## MATERIALS LICENSE

Amendment No. 56

REGISTRY OF RADIOACTIVE SEALED SOURCES AND DEVICES  
SAFETY EVALUATION OF DEVICE  
(AMENDED)

MODEL: SU-P77A and SU-77A

ATTACHMENT 2

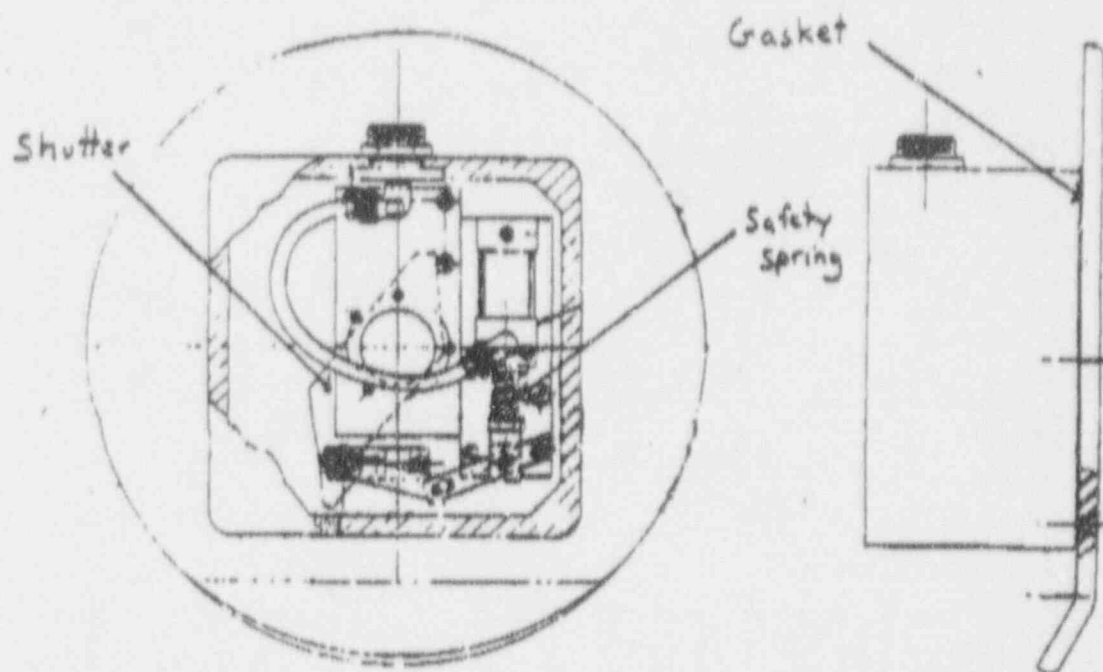
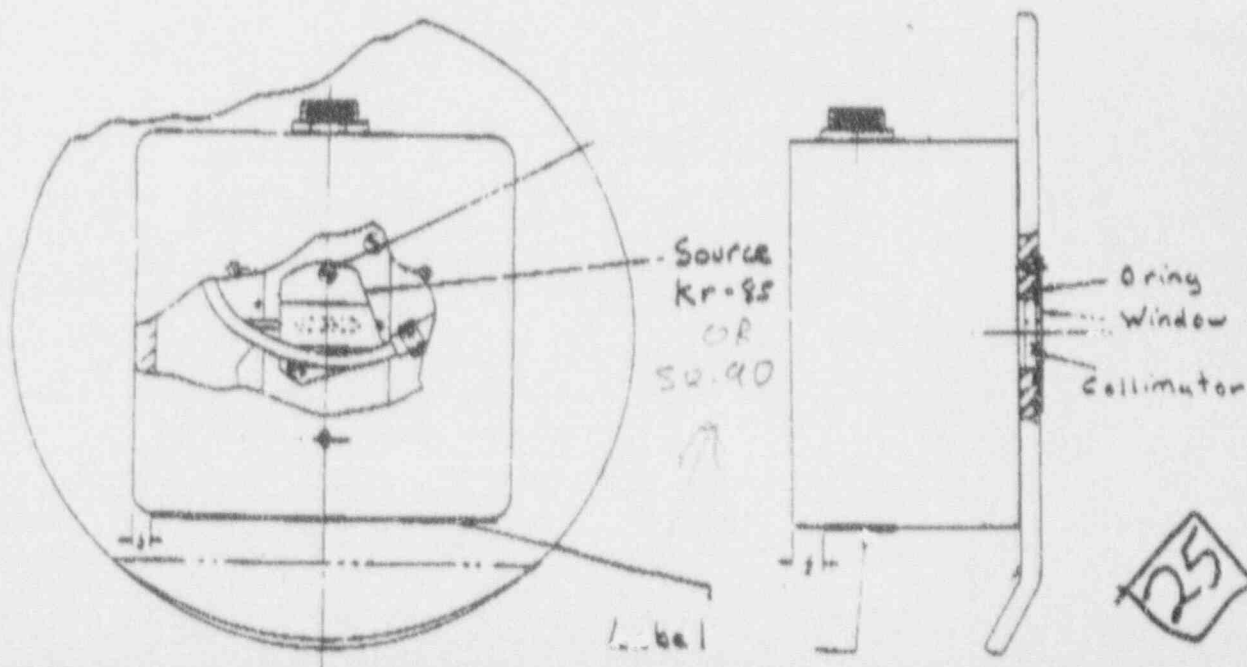
Attachment 2 - Add after KR-85 "or SR-90".

ATTACHMENT 3

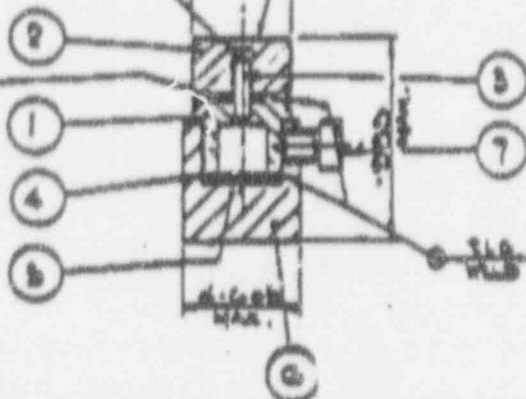
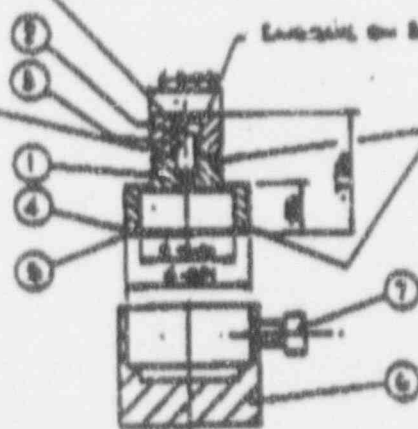
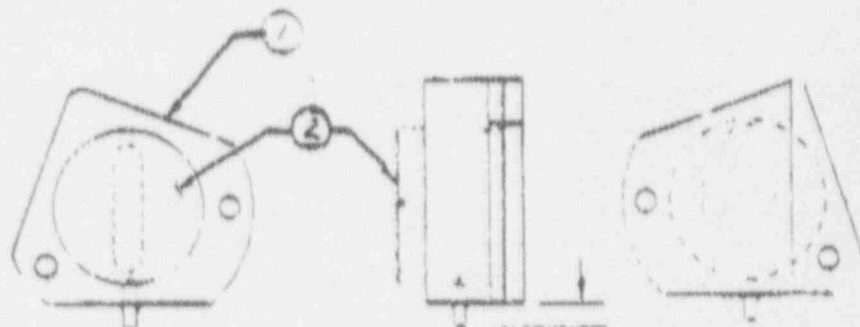
Attachment 3 - Add Page 2 to show Strontium-90 sources.

ATTACHMENT 4

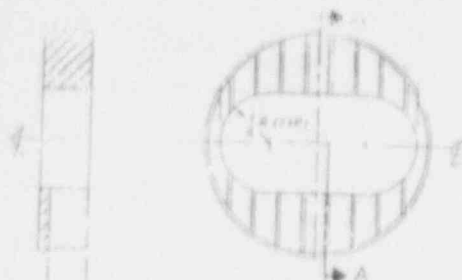
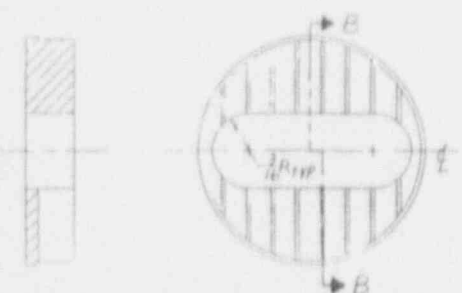
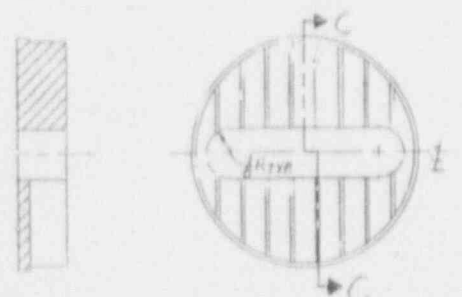
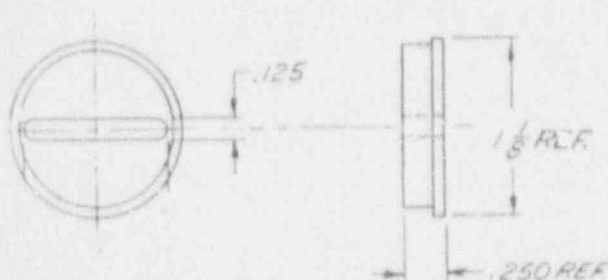
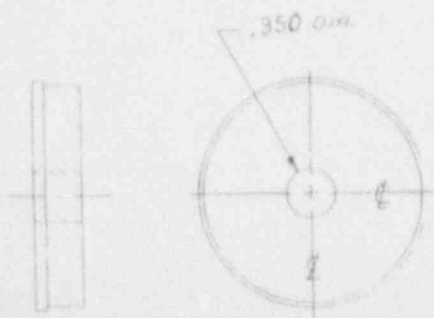
Attachment 4 - Revised to include collimators "F" and "H".
